DATE: 05 February, 2019  
FROM: Herrera Architecture, LLC  
119 S. 51<sup>st</sup> Street  
Omaha, NE

RE: **Addendum No. 2** to the Bidding Documents for:  
Project No: 00089-001 Sugar Creek Building 1  
General Contractor: Calabretto Building Group

Item No. DS-1, Sheet S1.1:

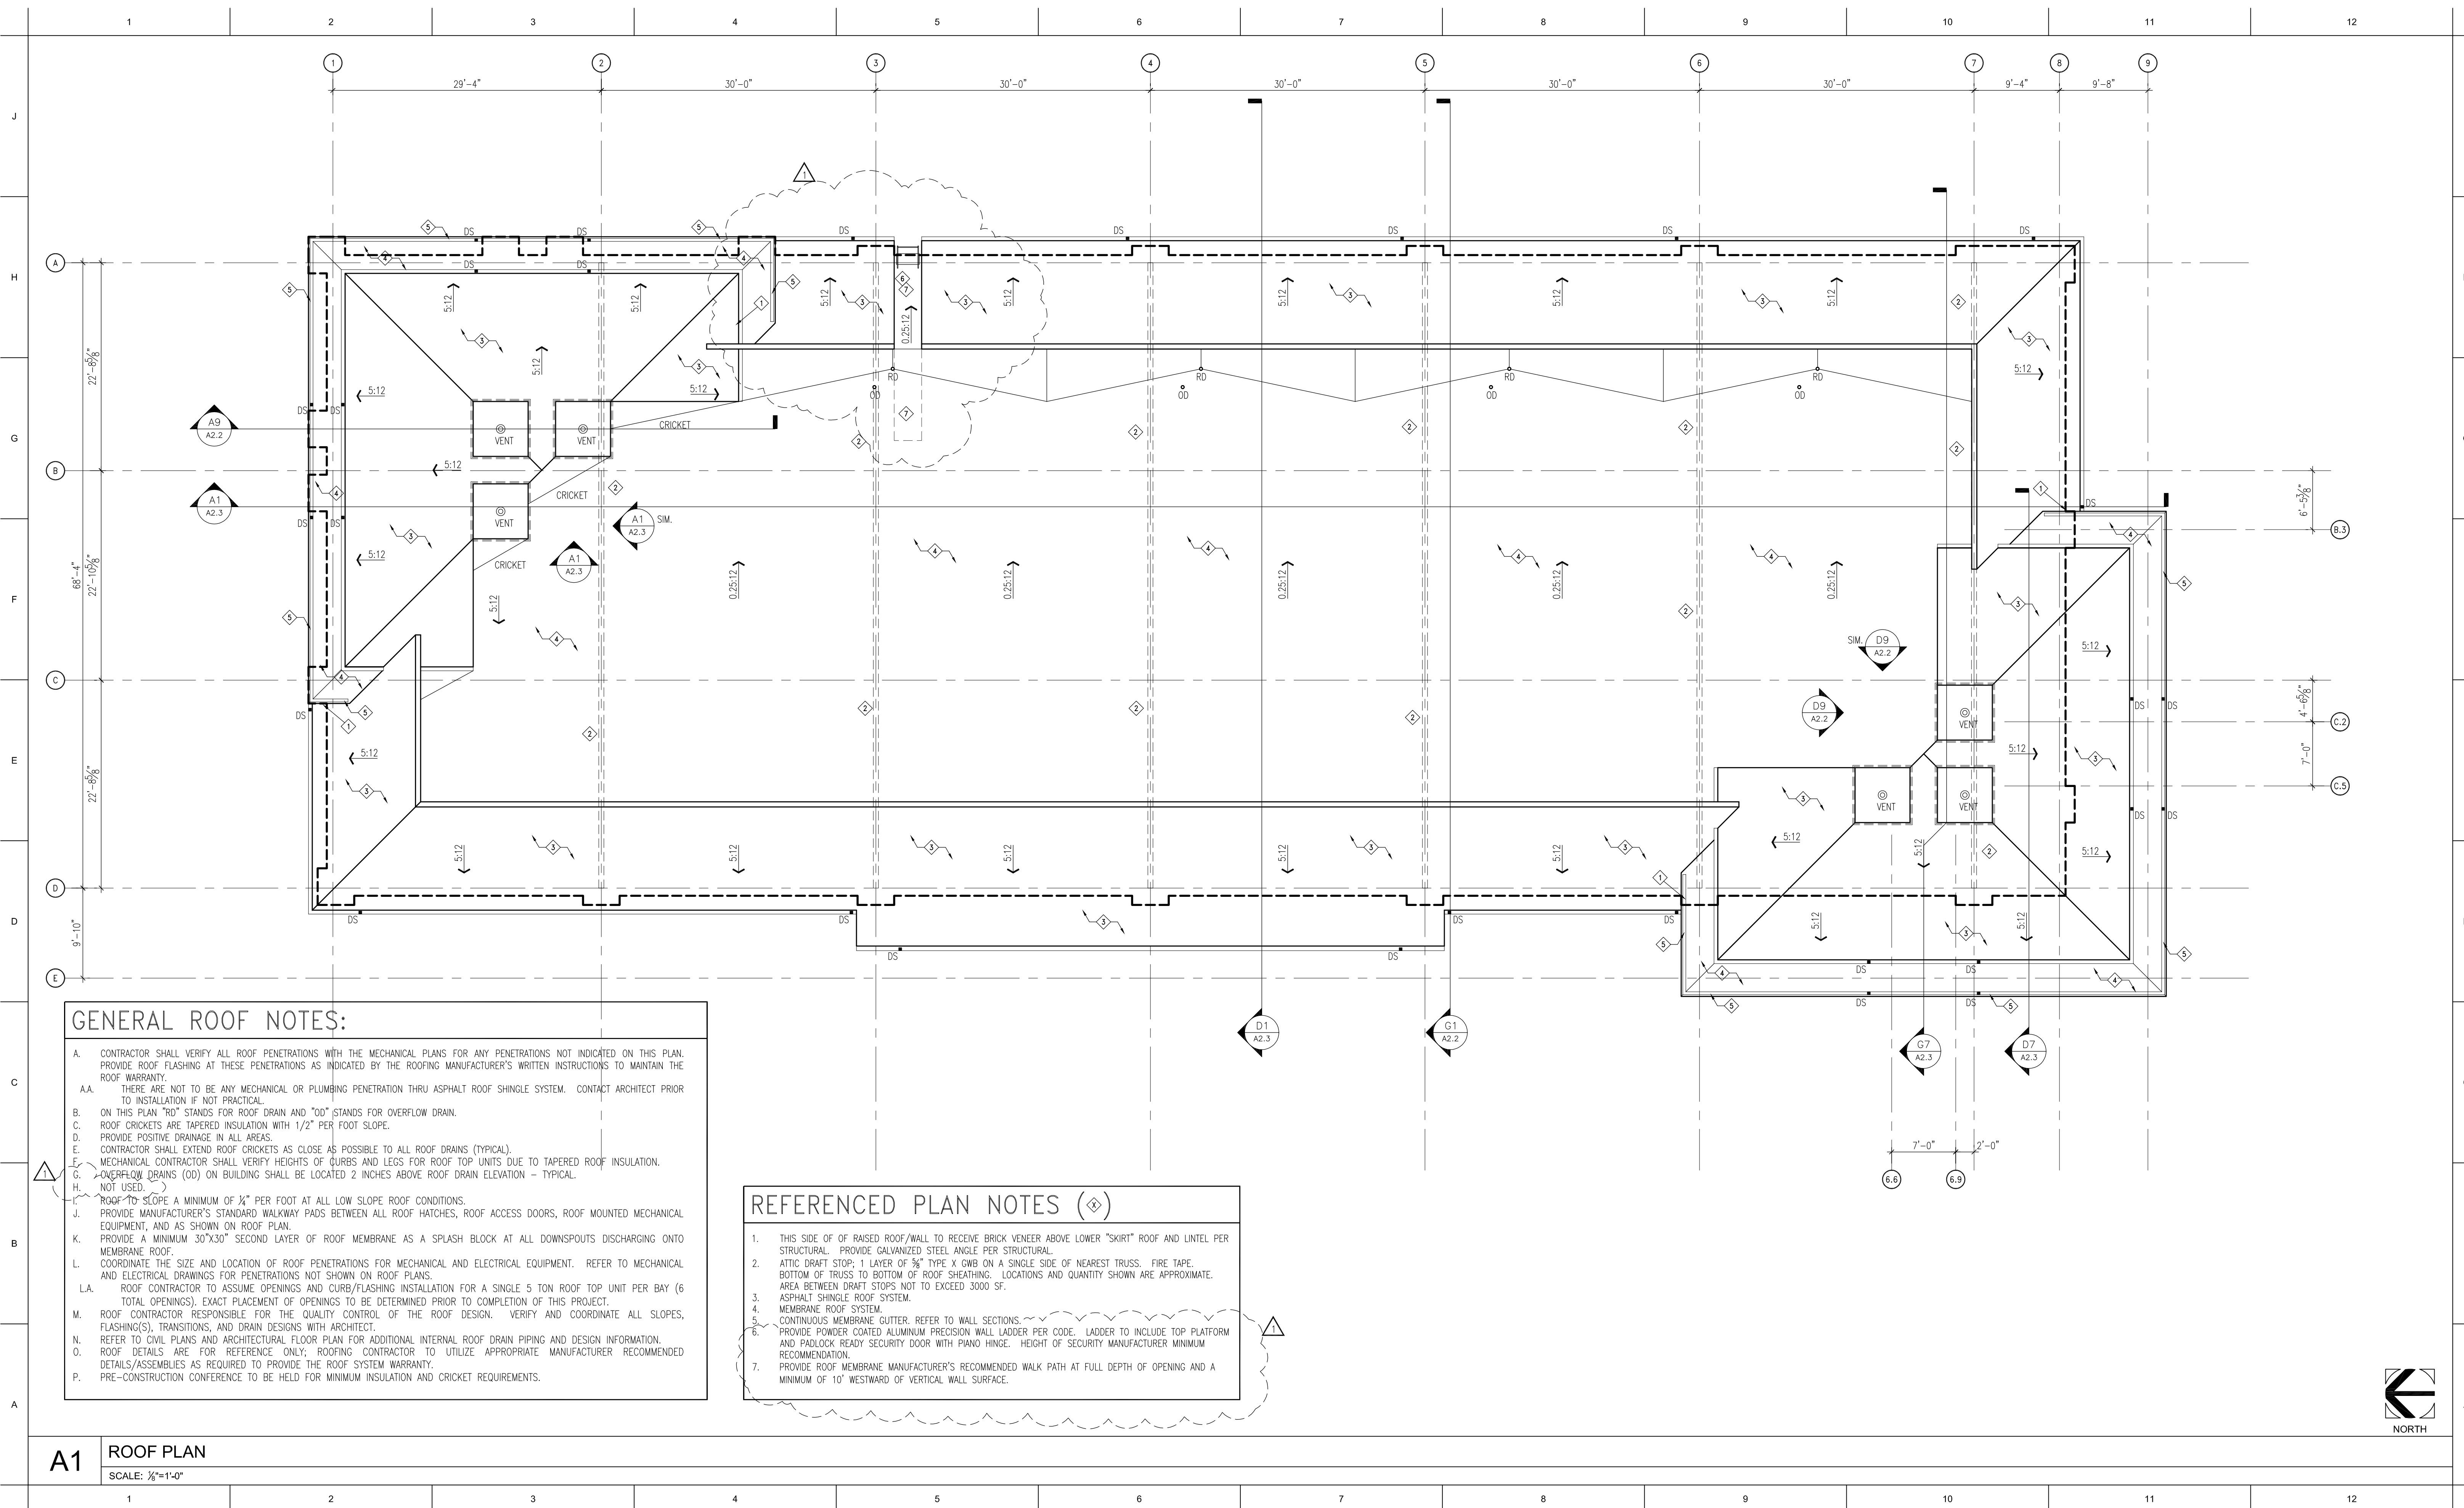
There are no steel columns required along Grid Line E and Grid Line 9. These brick column locations are wood framed with wood lintels and framing.

**A1** ROOF PLAN

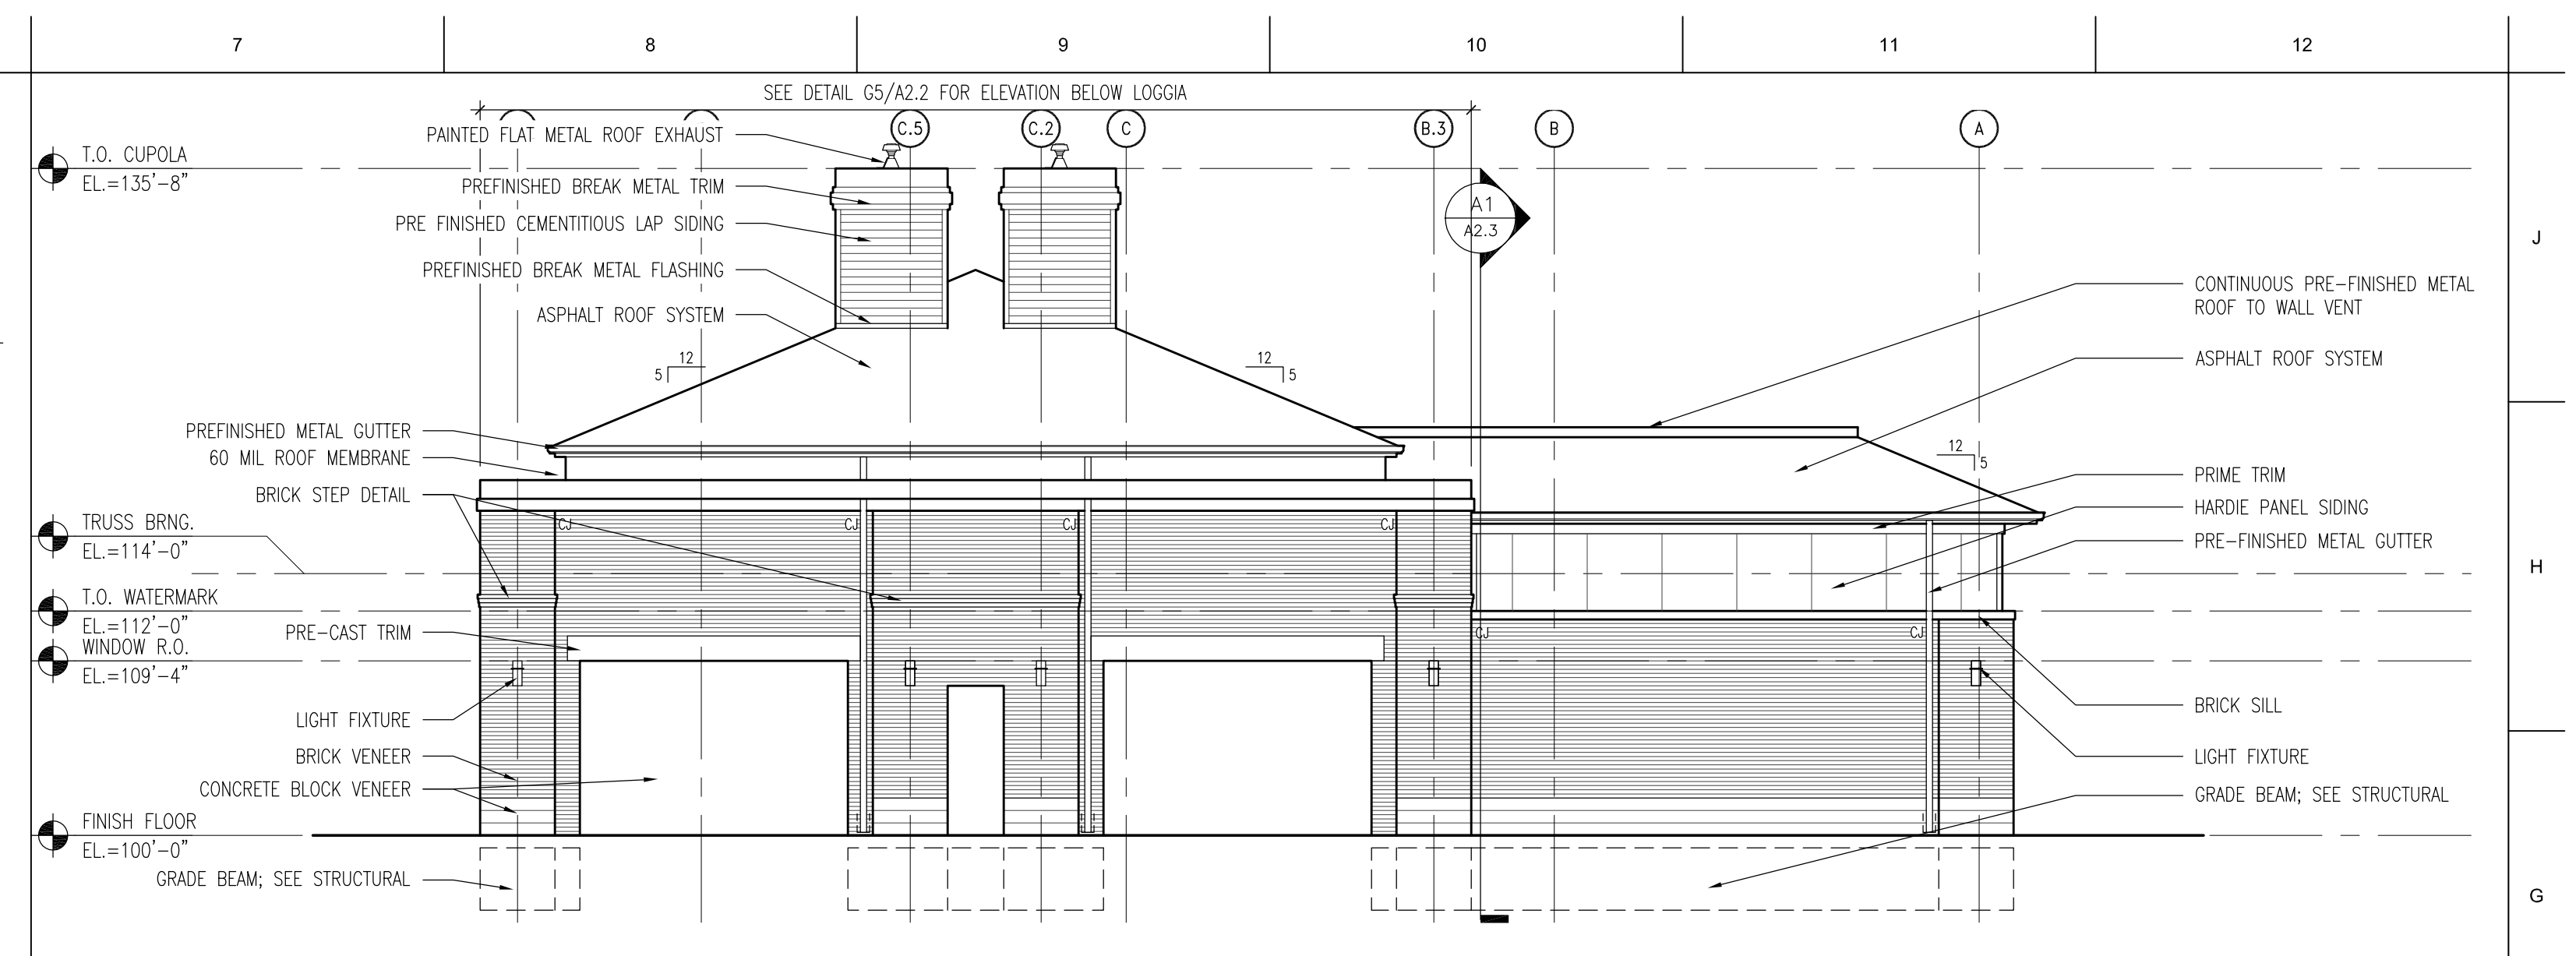
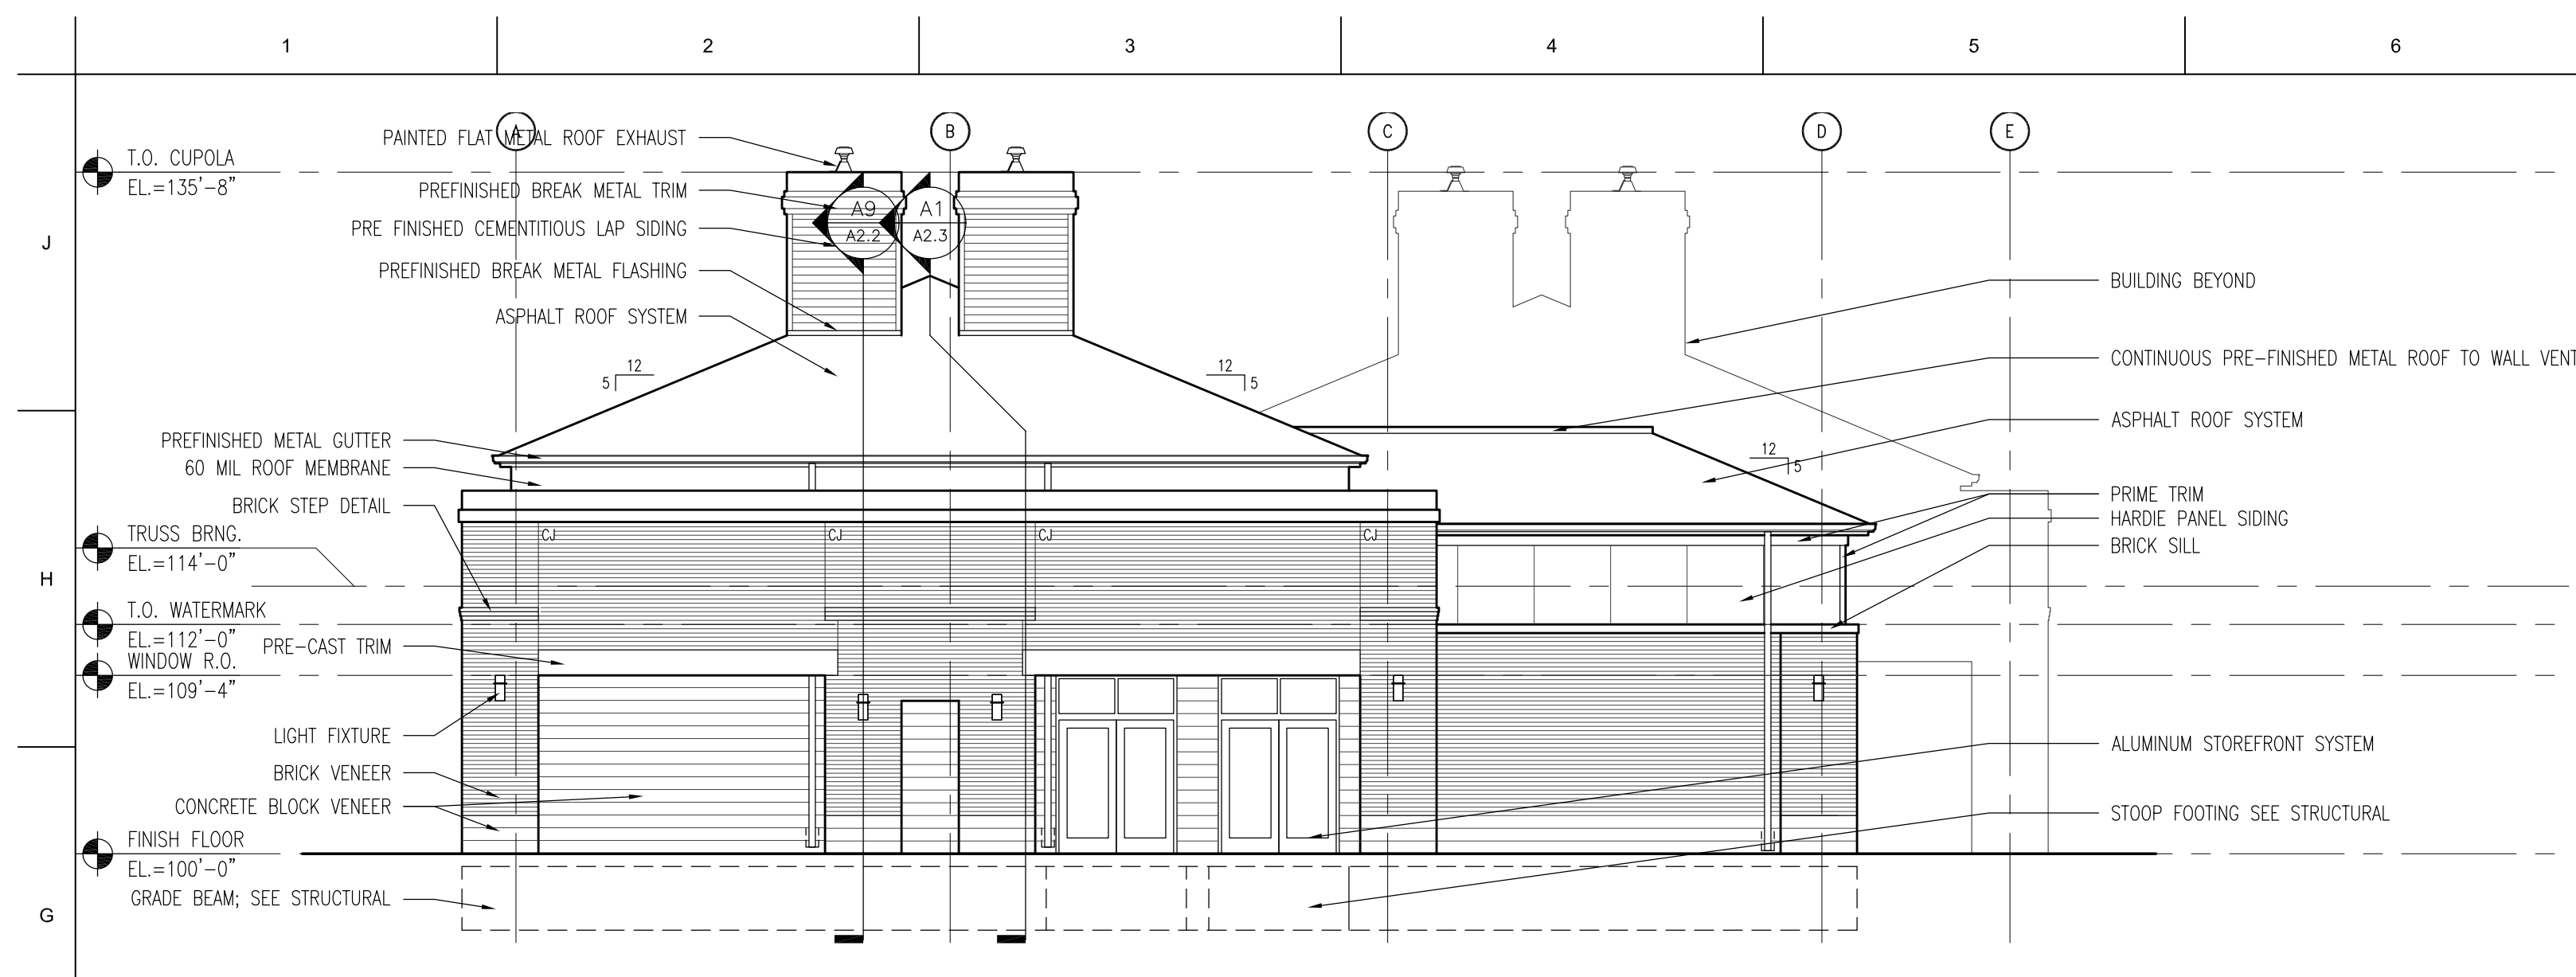
General Notes: Delete Item H. (Overhead thermal barrier is blow-in in the attic as shown throughout Drawings).

- G. OVERFLOW DRAINS (OD) ON BUILDING SHALL BE LOCATED 2 INCHES ABOVE ROOF DRAIN ELEVATION - TYPICAL.
- H. NOT USED.
- I. ROOF TO SLOPE A MINIMUM OF 1/4" PER FOOT AT ALL LOW SLOPE ROOF CONDITIONS.
